Access Compliance Report

Public Rights-of-Way

Intersection ID: 10037285	Main Street: SARDIS_RD_NORTH	Cross Street: N/A	Location: NE
ADA ID: 6B447F9664D5	Ramp Type: Para	Initial Pass/Fail: Fail	Overall Compliance: No
Codes/Mitigation Info/Possible Solution		Field Measurements/Component Compliance	
Severity Score: 13.75

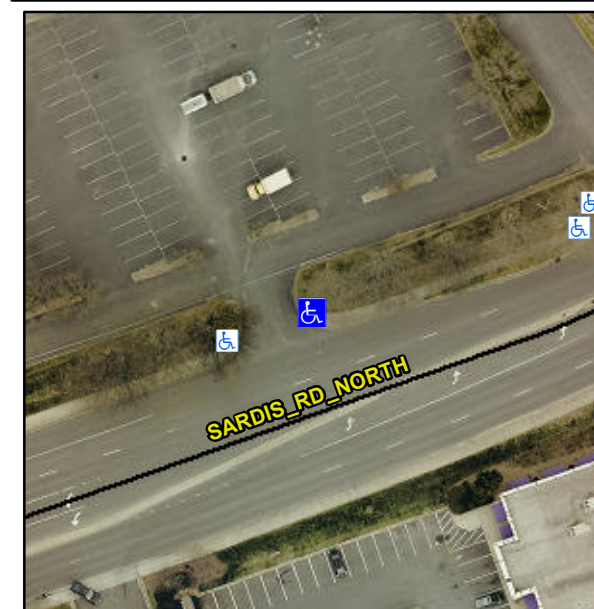
LT RP < 5%

R304.5.3, R304.3.2

Compliance	Description	Data	Compliance	Description	Data
N/A	Ramp Length LT (in)	48.0	N/A	Ramp Length RT (in)	52.0
Yes	Ramp Width LT (in)	70.0	Yes	Ramp Width RT (in)	72.0
Yes	Ramp Slope LT (%)	3.5	No	Ramp Slope RT (%)	11.1
No	Ramp XSlope LT (%)	3.2	No	Ramp XSlope RT (%)	2.1
N/A	Landing Length (in)	N/A	N/A	DWS Provided?	N/A
N/A	Landing Width (in)	N/A	N/A	DWS Contrast?	N/A
N/A	Landing Slope (%)	N/A	N/A	DWS Length (in)	N/A
N/A	Landing X Slope (%)	N/A	N/A	DWS Full Width?	N/A
N/A	Landing Curb? (Y/N)	N/A	N/A	DWS Offset (in)	N/A
N/A	Shared Landing?	N/A			
N/A	Gutter Ponding?	N/A	N/A	Gutter Slope (%)	N/A
N/A	Gutter Lip Ht (in)	N/A	N/A	Gutter X Slope (%)	N/A
N/A	Painted X Walk1?	No	N/A	Painted X Walk2?	N/A
	X Walk 1 Direction	To SW		X Walk 2 Direction	N/A
N/A	X Walk 1 Width (in)	N/A	N/A	X Walk 2 Width (in)	N/A
	X Walk 1 Slope (%)	0.5		X Walk 2 Slope (%)	N/A
	X Walk 1 X Slope (%)	2.4		X Walk 2 X Slope (%)	N/A
N/A	Ramp inside XWalk1?	N/A	N/A	Ramp inside XWalk2?	N/A

Remove & Replace Entire Ramp.
